CITY OF ST. PETERSBURG, FLORIDA
PLANNING & DEVELOPMENT SERVICES DEPT.
DEVELOPMENT REVIEW SERVICES DIVISION

STAFF REPORT
DEVELOPMENT REVIEW COMMISSION - VARIANCE REQUEST
PUBLIC HEARING

CASE NO.:	21-54000014	PLAT SHEET:	E-16
REQUEST:	Approval of a variance to the front yard setback from 30-feet required to 23.45-feet proposed for an entry wall approximately 14-feet tall and an appeal to a previously denied administrative Design Variance to recognize Dutch West-Indies as a permitted Architectural Style in the NT-3 Zoning District.		
OWNER:	Richard Hughes 2925 1 st Street Northeast Saint Petersburg, Florida 33704-2907		
ADDRESS:	2925 1 st Street Northeast		
PARCEL ID NO.:	07-31-17-32598-001-0030		
LEGAL DESCRIPTION:	On File		
ZONING:	Neighborhood Traditional Single-Family (NT-3)

PROPOSED FRONT ELEVATION

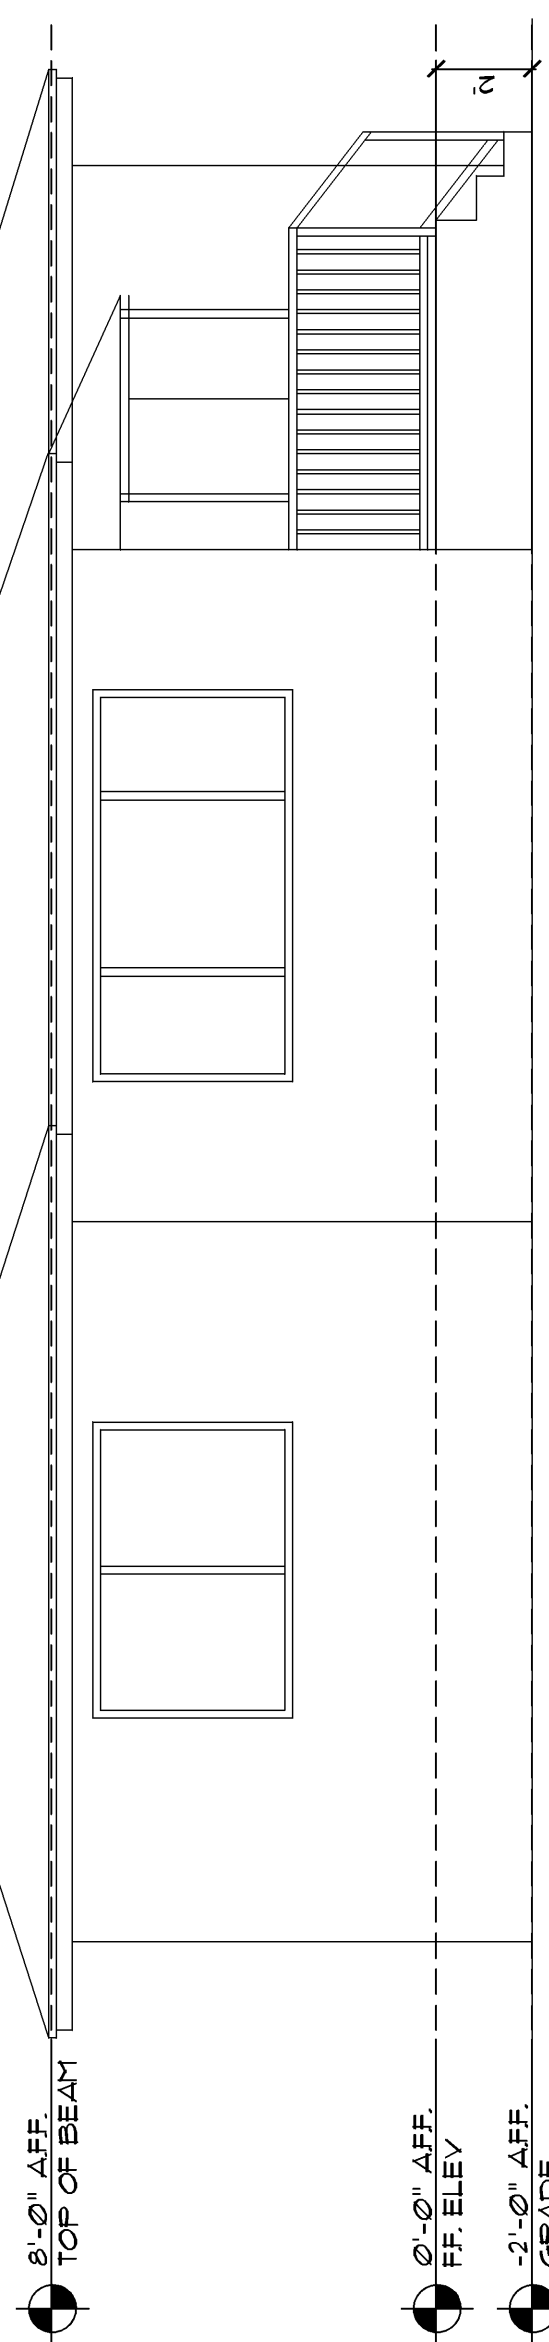
The applicant is proposing to expand the existing front porch to be 23.45-feet from the front property line to construct a 14-foot tall entry feature wall. Per Code Section the maximum height for a wall in the front yard is 4-feet. A literal enforcement of this chapter would not result in unnecessary hardship. The applicant can have a wall in this area, however the maximum wall height would be 4-feet.

The granting of the variance will not be in harmony with the general purpose and intent of this chapter. The proposed wall exceeds the maximum height allowed of 4-feet for walls in the front yard. Also the Dutch West-Indies Style is not present in the either of the acceptable references listed in Code Section 16.40.020.1. for approved architectural styles.
